From: Michael Eastham
Sent: 05 July 2017 17:21
To: Planning.Responses
Subject: FW: Fitzalan Link - LU.234.16.RES

From: Michael Eastham [<mailto:Michael.Eastham@arun.gov.uk>]
Sent: 05 July 2017 13:23
To: Graham, Laura
Subject: FW: Fitzalan Link - LU.234.16.RES

Following review of the submission, WSCC comments as follows:

In summary, there appear to be just three outstanding points now – the choice of road surface, the requirement for a new or supplementary Stage 1 Road Safety Audit and the design of the shared footpath-cycleway connection to Highdown Drive close to the new Toucan crossing now proposed. The other points can be tied-into the detailed S38/S278 submission.

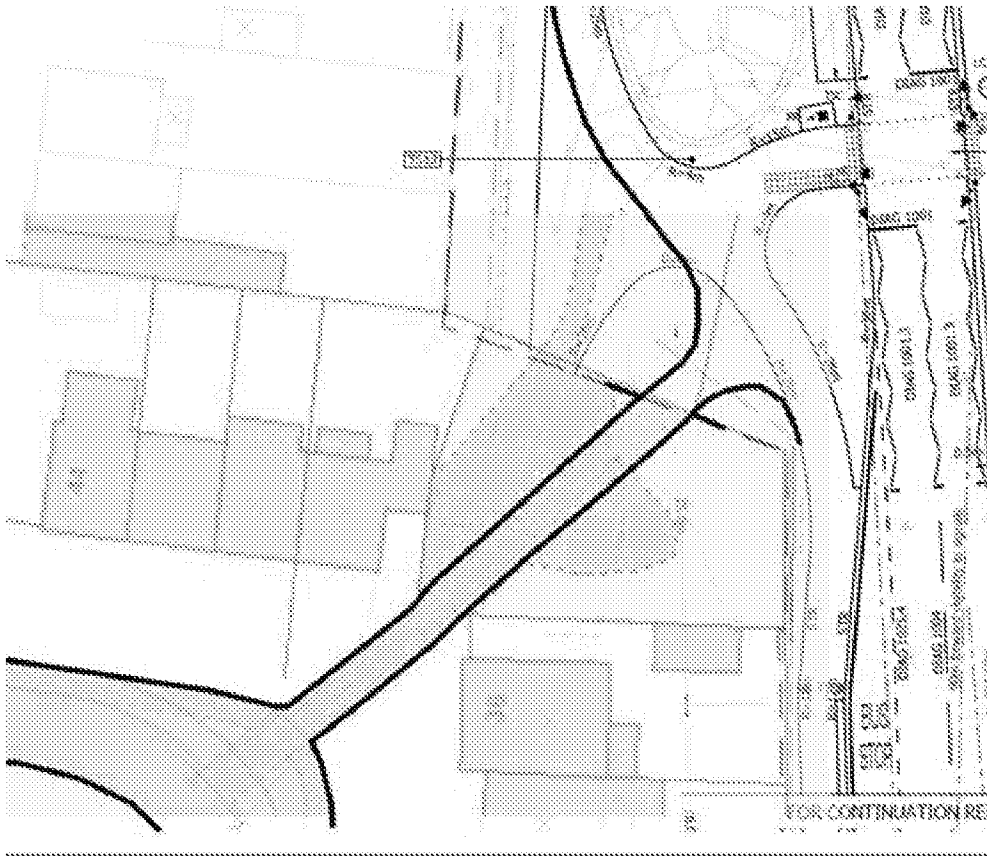
You have again offered an explanation for the path alignment in the vicinity of the Toucan crossing and balancing pond. The radii proposed are acceptable to us but the path must connect properly to the path leading to Highdown Drive which should be upgraded to a shared footway-cycleway. I have indicated below what this might look like. However, looking at this again shows the pink area to be public highway and on the line of part of Public Footpath 3103. Therefore, it is recommended (and indeed appears more straightforward) to retain this line otherwise it appears that any continuation of the route south of your scheme might cross land that might not be highway. Any path should be lit, edged, resurfaced, signed and tactile-paved appropriately although these final details can be shown at the S38/278 stage. Any upgrade from Public Footpath to shared footpath-cycleway must be undertaken in accordance with WSCC PROW procedures.

The highway boundary plan and alignment of the existing PROW is noted. However, this is not evident on the ground since the Academy has been constructed (see extract from Google Earth below). We can show the alignment requested, (based on the OS Highway Boundary plans provided) but we would only have the power to construct the pathway up to our limit of ownership (the red line). WSCC has less than Freehold rights beyond the red dashed line and as such we don't believe we would have any power to undertake works on this area of land (see attached) to effect the PROW route beyond the red line, hence the reason for showing the tie-in (at the limit of ownership) to the existing physical route present on the ground. Therefore, we believe that what we have shown on the submitted drawings is the best solution, unless WSCC can confirm that we could legally obtain power to undertake works on land that they don't have complete freehold rights over. The legal line of the highway south of the Persimmon land is as shown in pink of the extract found below taken from my earlier email of 24th May 2017. As such, this is the line that should be used. As such, Persimmon should show their connection to the point shown on their boundary to ensure appropriate connection with the correct alignment. Persimmon to provide appropriate signage, lining, tactiles etc.
